PROGRESS REPORT (FIRST DRAFT)
U.S. Army Corps of Engineers Waterways Experiment Station
Corps of Engineers Contract No. DACW39-92-M-6666

STRIP DRAIN TEST SECTION IN CRANEY ISLAND DREDGED MATERIAL MANAGEMENT AREA

NOTE TO REVIEWERS

This is a first draft of a progress report describing the vertical strip drain test section in the Craney Island Dredged Material Management Area. It is estimated that the dredged fill and marine clay will reach 90 percent consolidation in February or March, 1994. As a result, the data pertaining to the test section will be augmented as consolidation progresses. The main purpose of submitting this progress report for review is to obtain suggestions for improving the data presentation and analysis prior to completion of the project. It is anticipated that the input of reviewers at an early stage will improve the final report. Upon completion of the test section and incorporation of the final test results, the report will be submitted for a final review. Thank you in advance for contributing to the improvement of this research.

Figure 6. Generalized Subsurface Profile at Craney Island

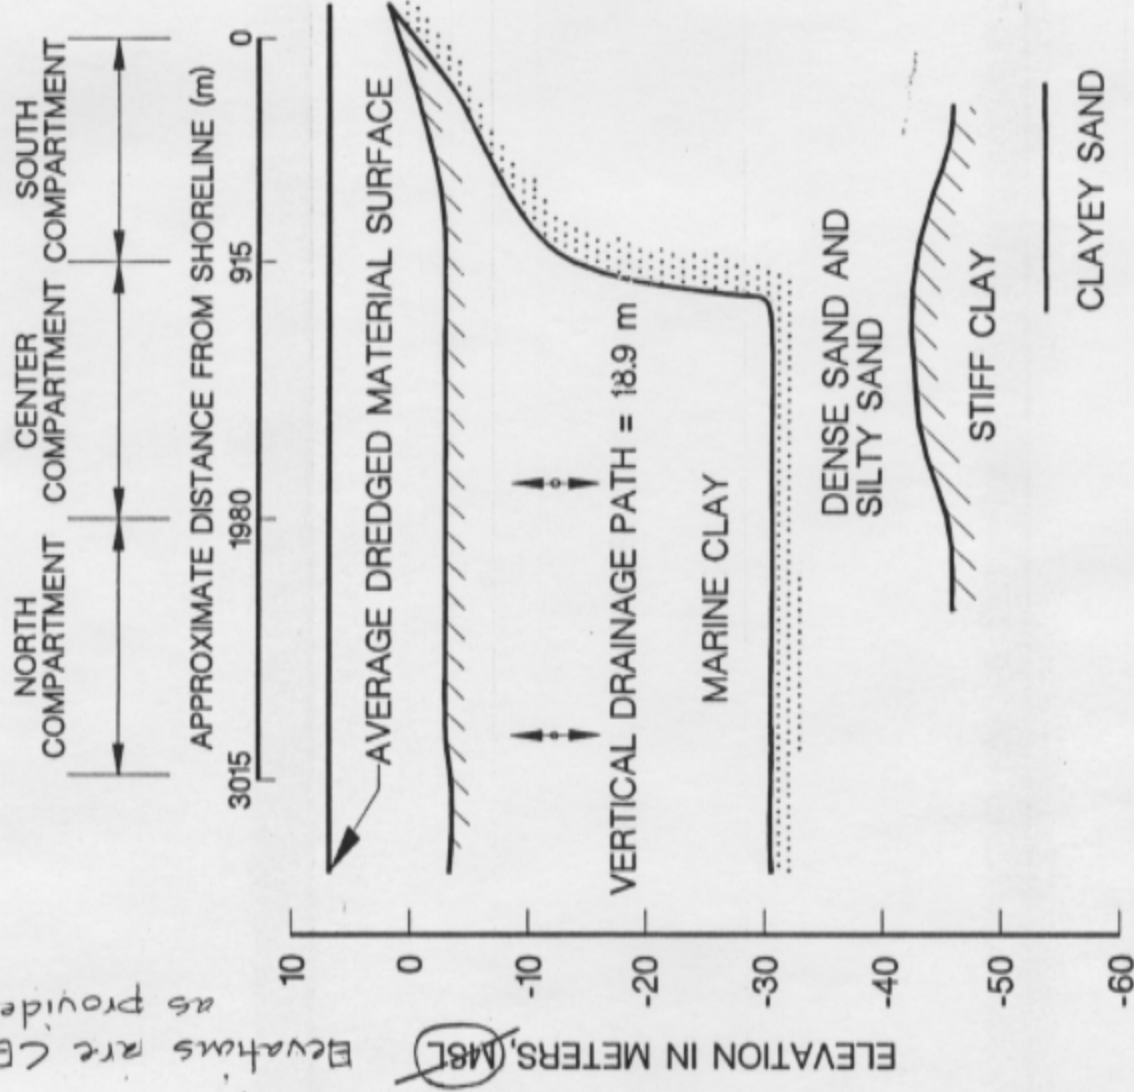
No longer used
Elevations are CEMW not MSL
as provided

Places mudline C ^{high} -3.2m. Original was about -3.0m (-10ft) to -4.0m (-13ft). Also conflicts w/ 13.5m (-6.2m) as stated on Pg 19. Latter figure agrees w/ Corps findings.

(Location was based on as far west as dredge pipe allowed. We were aware of channel and decided we best find out now if it was problem. See soil profile along entire perimeter dikes. Channel is evident.)
an old river channel is located. The strip drain test section, described in Part III, was inadvertently located above this old stream channel, and thus the maximum vertical drainage in this area is approximately 22 m. For illustrative purposes the marine clay will be assumed to be 27.5 m thick. Recent piezocone penetration tests in the north compartment described herein suggest that the underlying dense sand and silty sand are permeable.

Figure 27. Installed Strip Drains and Pontoon Mounted Equipment

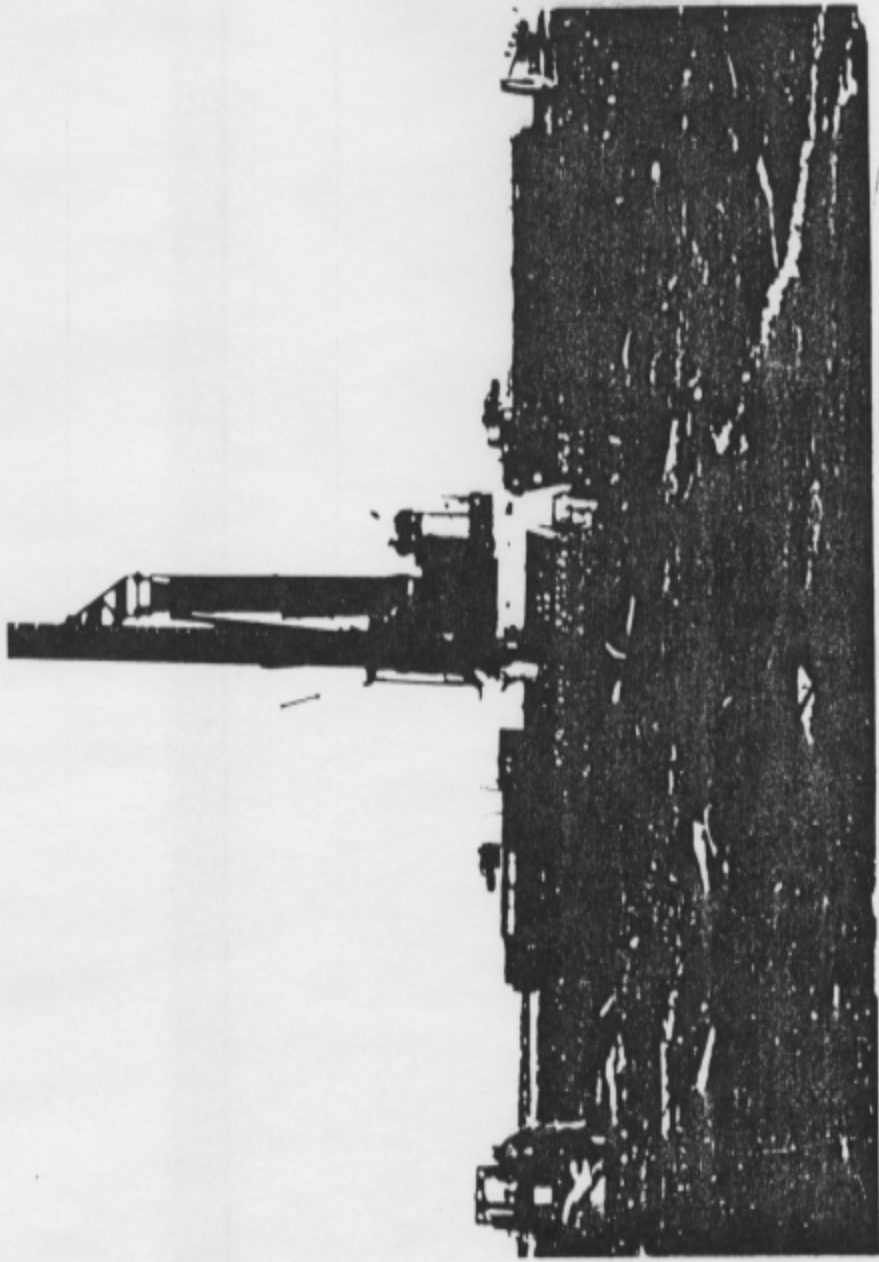
Out of Place. Follows Pg 28

Figure 17. Excess Pore-Water Pressure Under Craney Island Strip Drain Test Section

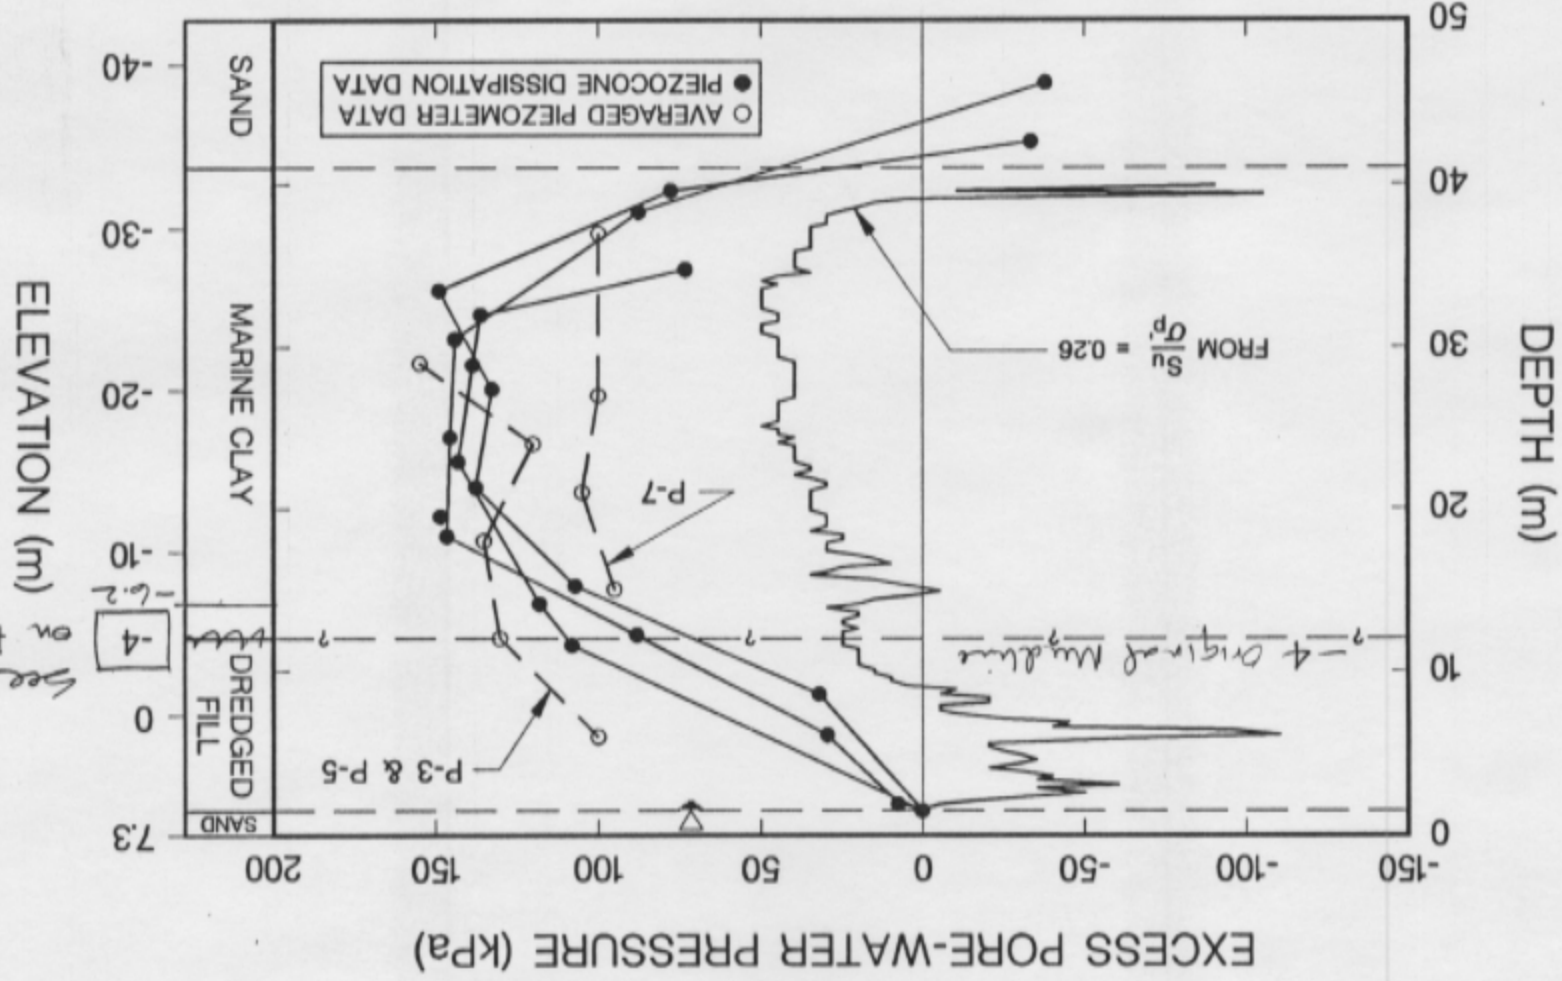
See comment on Pg. 10 & 19. Figure 20.

Figure 20. Undrained Shear Strength versus Depth in Craney Island Strip Drain Test Section

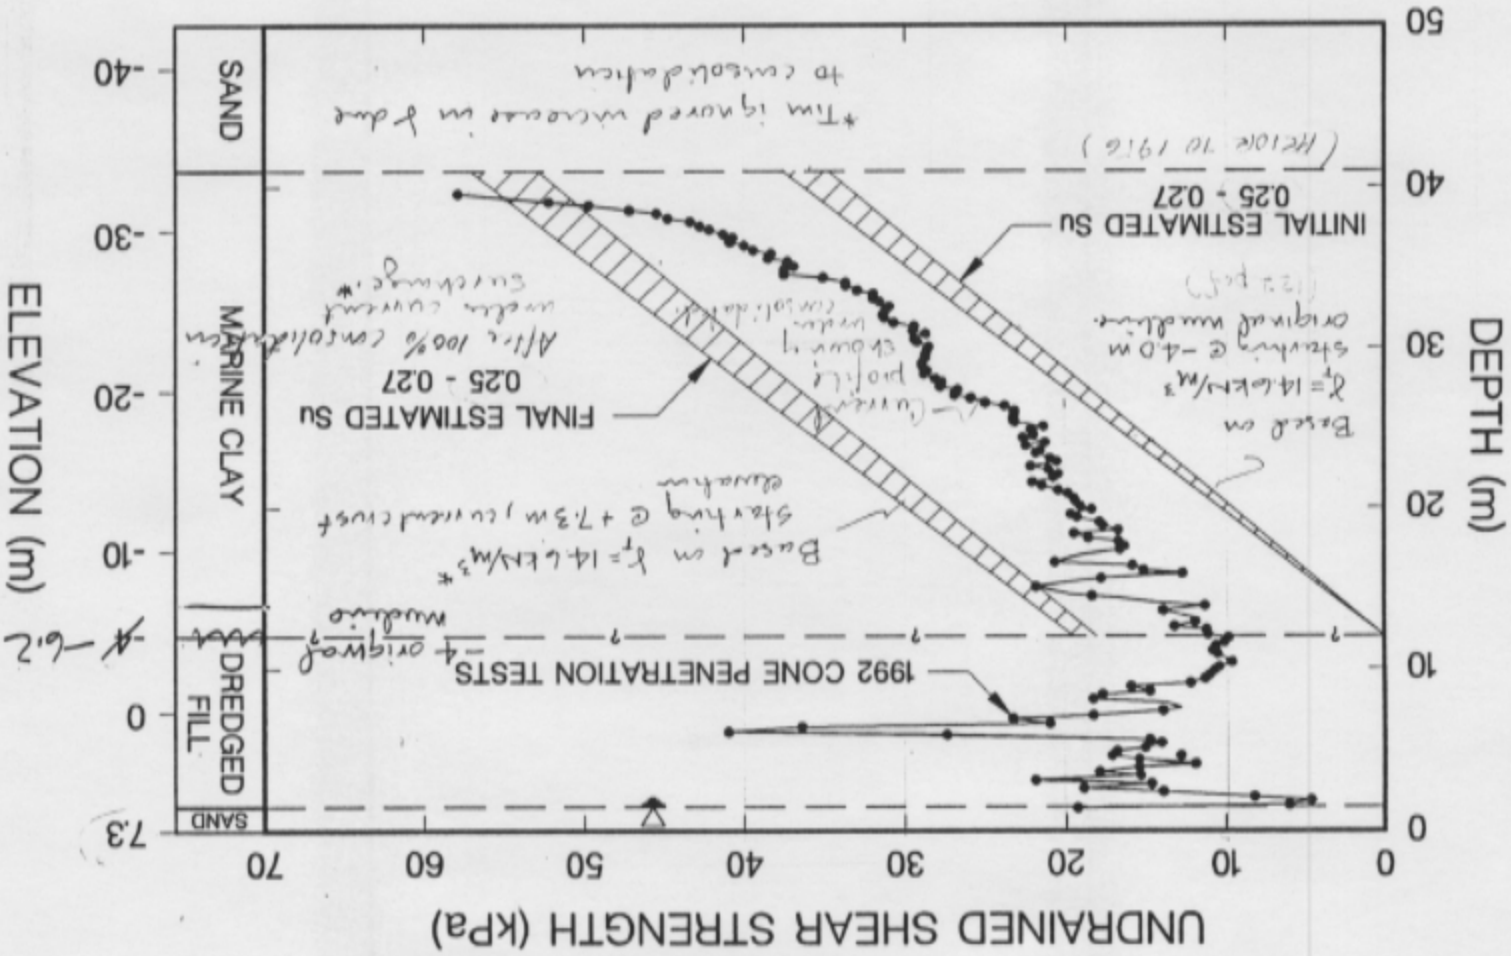
See P. 10, 19, 17. Fig 17.

* For simplicity, assume $\delta_r = 14.6 \text{ kN/m}^3$, same as unit weight used for initial profile. Actually need to compute what δ_r would be after 100% consolidation under self weight. Based on 1992 data, δ_r was increased to 14.9 kN/m^3 . (Using δ_r from CPT's, previously $U_{50\%}$. δ_r at 100% would be in order of 15.2 kN/m^3 in general calls)

Figure 23. Void Ratio versus Depth in the Craney Island Strip Drain Test Section after 100% consolidation

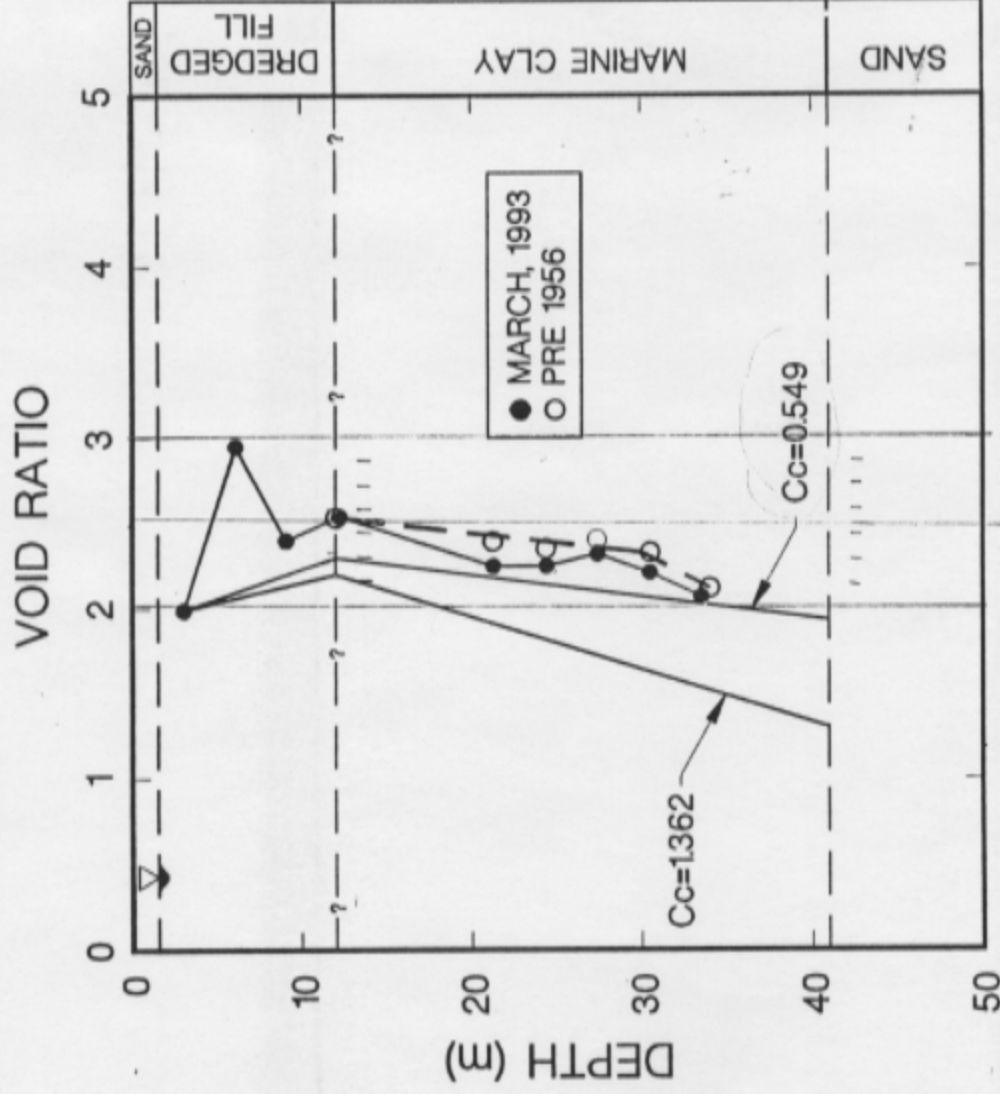
suggest delete
material
belong
Pg 33. use
a figure, & in
and clay
it had more
can also explain
about it
one developed

Used to explain how developed straight line plots.

Figure 25. Void Ratio-Effective Stress Relationship for Marine Clay (after Ishibashi et al. 1992)

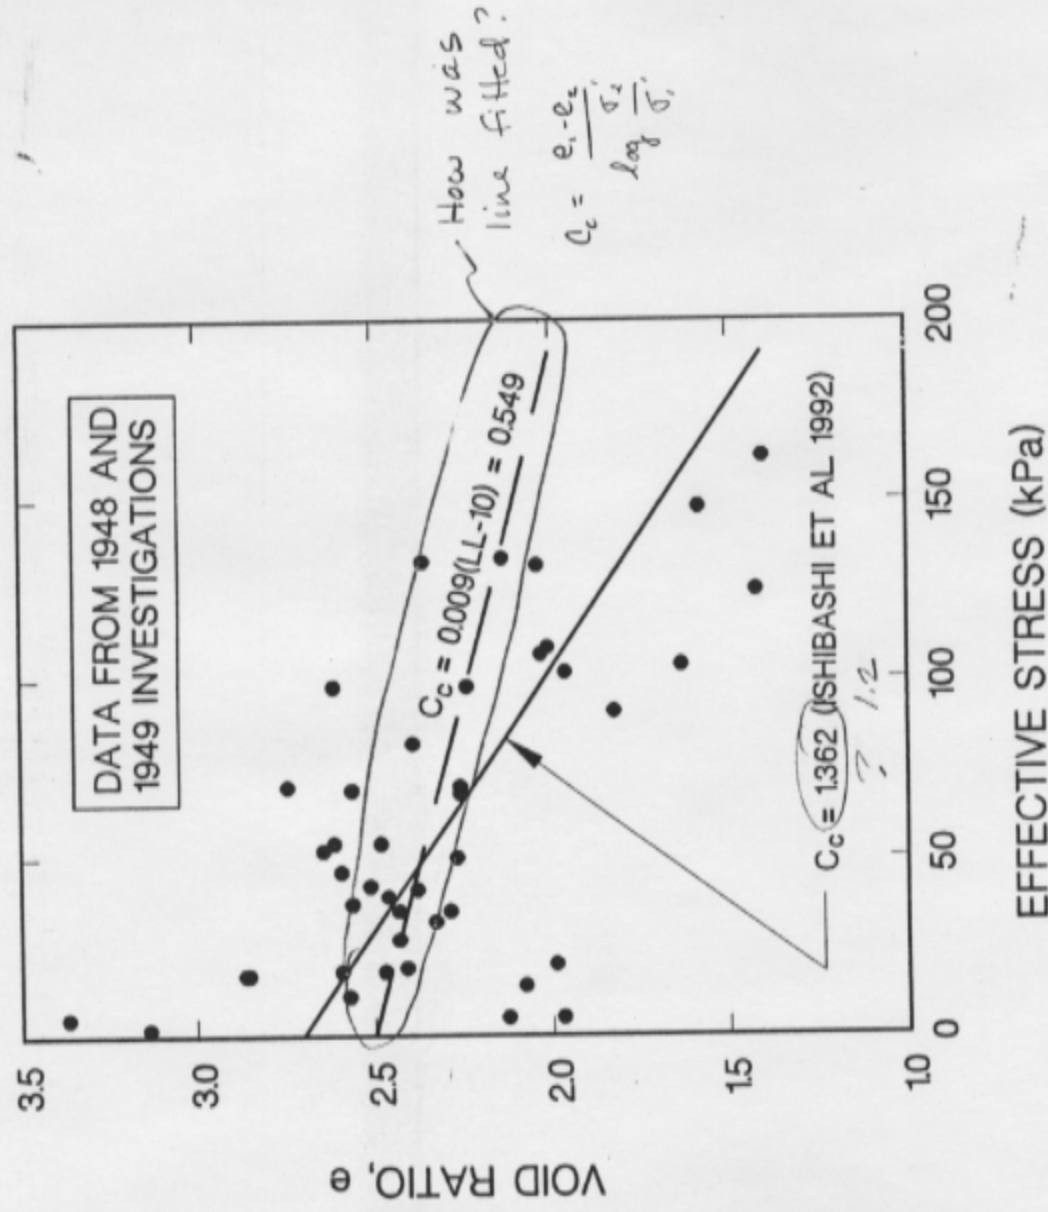
Are these C_c independent of units?
Check C_c against ODU report.

Figure 26. Overview of Strip Drain Equipment

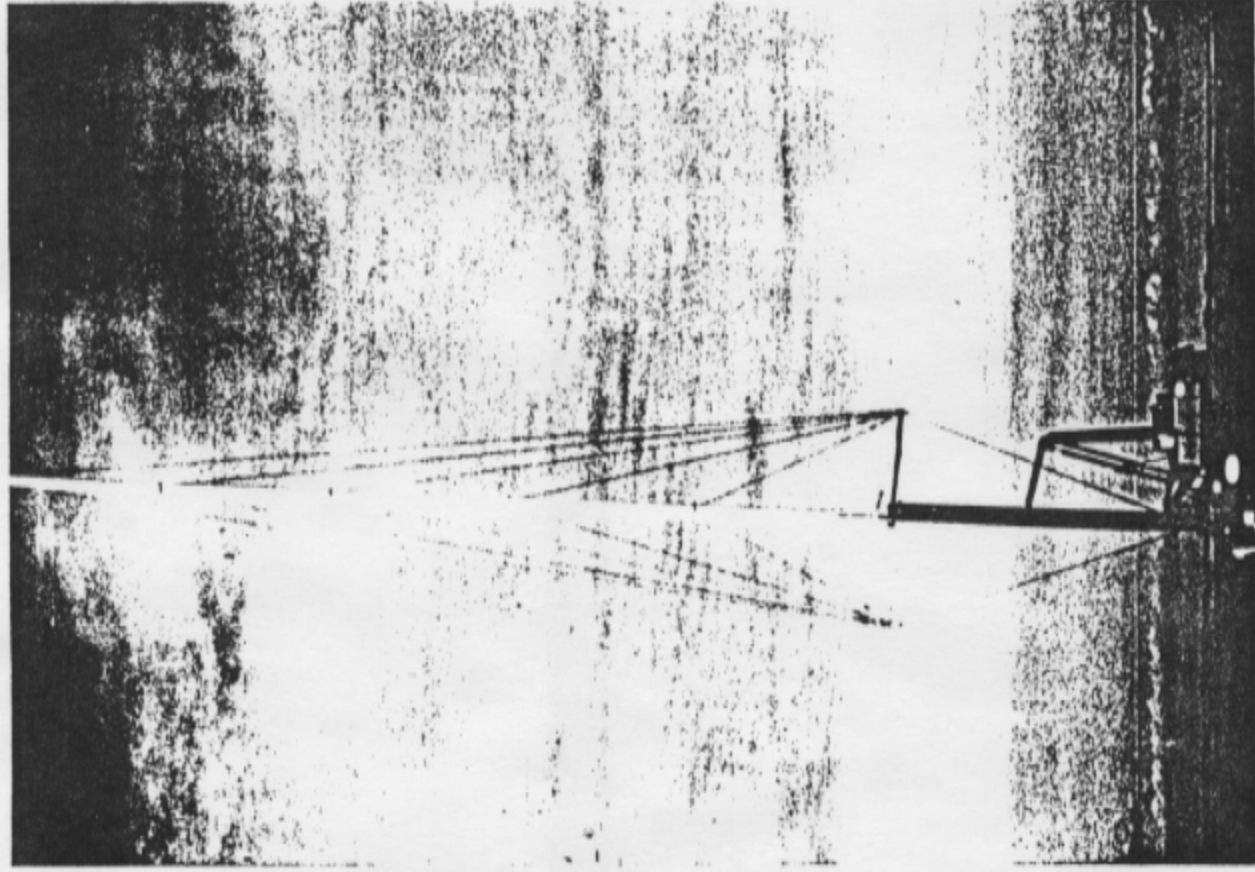
Report in SI units, if discussing weight (force) then need Newtons. If discussing mass, then need to change wording.

Figure 30. Settlement Plate Measurements in Mobility Section

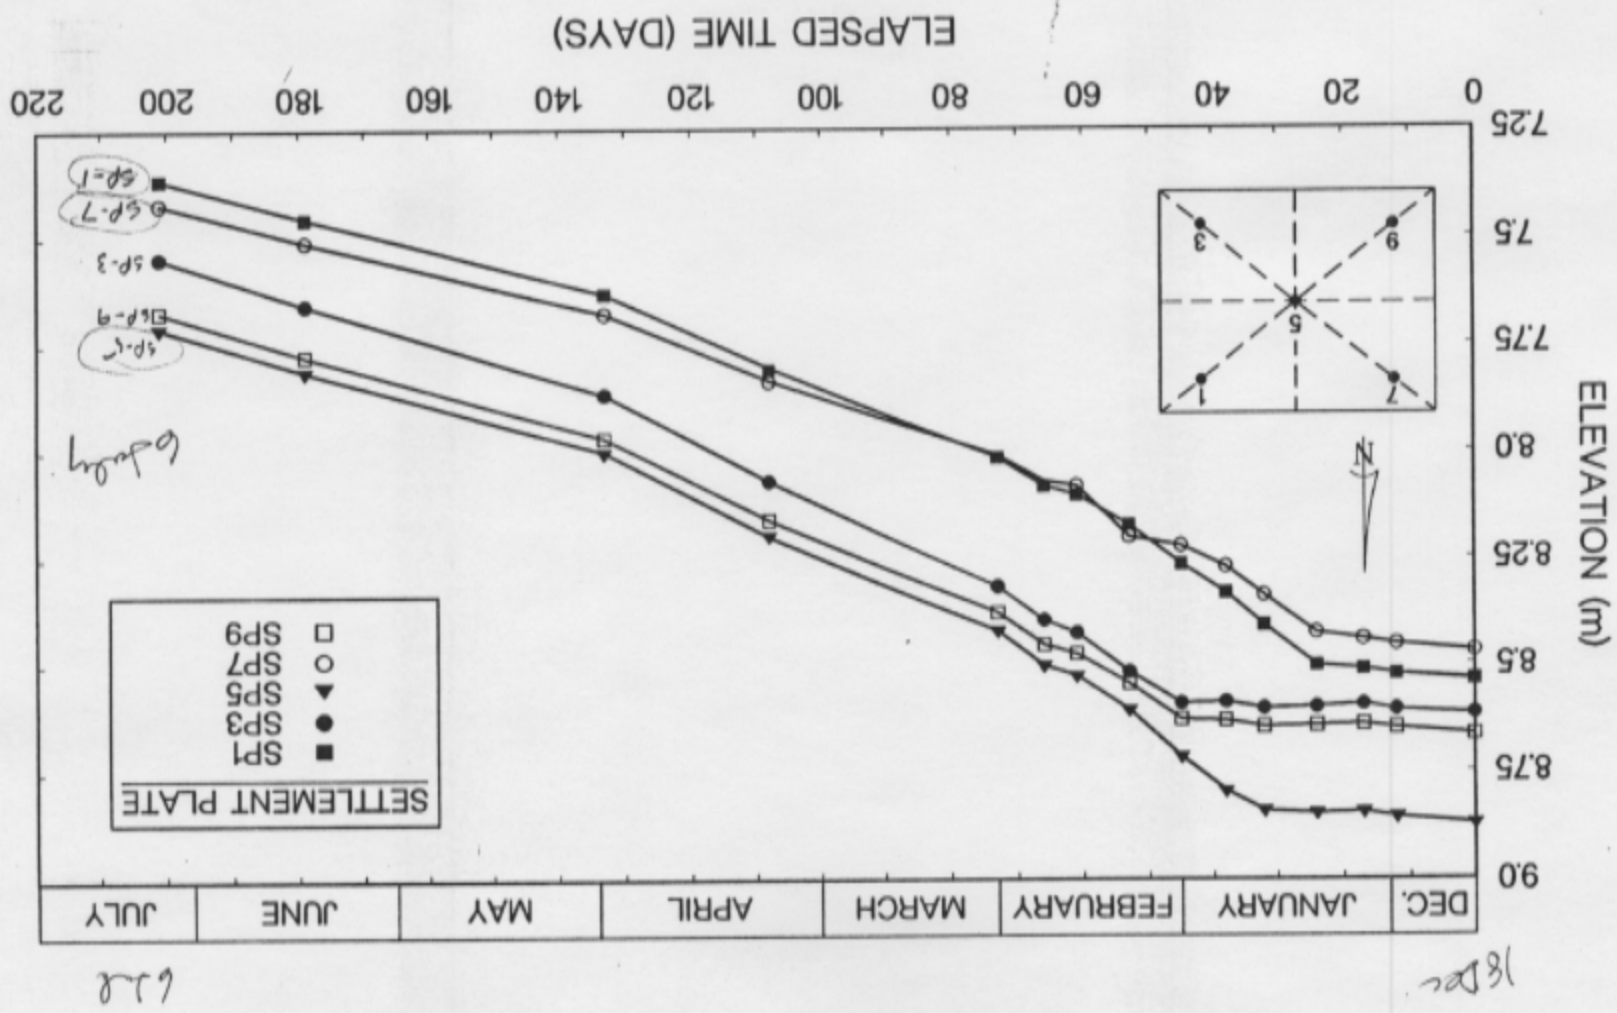
See comment by 34. Estimated settlement does not address effect of blanket. Should compare settlement to SP-10. Also put in SI units.
